5					4					3					2					1																			
MODEL:					REV:					CHANGE LIST:															MODEL					ZU1									
ZU1 FINGER PRINTER BOARD					1A					FIRST RELEASE															PAGE					FROM					TO				
					1B					PLEASE REFER TO ECN E200611-0701															1					1A					1B

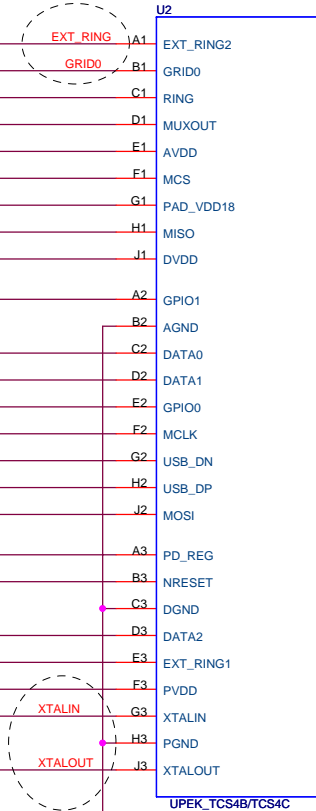
A1A: (11/01) Change Pin Hrader from 6pin to 8pin
A1B: (12/21) Change Pin Hrader P/N from DFHD08MS002 to DFHD08MS004

B3A: (03/09) Based on vendor's suggestion,
change C5 from 0.1uF(CH41002KB93) to 1uF(CH5101K9B01)
change R7 from 47K(CS34702JB21) to 330K(CS43302JB18)

B3A: (03/09) Based on vendor's suggestion,
change C3 from 47pF(CH04706JBD4) to 33pF(CH03306JB04) for TCS4B
change C3 from 47pF(CH04706JBD4) to 22pF(CH02206JB08) for TCS4C

A1A:(10/31) Rename net name from ESD_GND to GND.

B3A: (03/09) Based on vendor's suggestion,
change C2 from 18pF(CH01806JB07) to 0pF for TCS4B
change C2 from 18pF(CH01806JB07) to 47pF(CH04706JBD4) for TCS4C

A1A:(10/23) Add net name.

A1A:(10/23) Add net name.
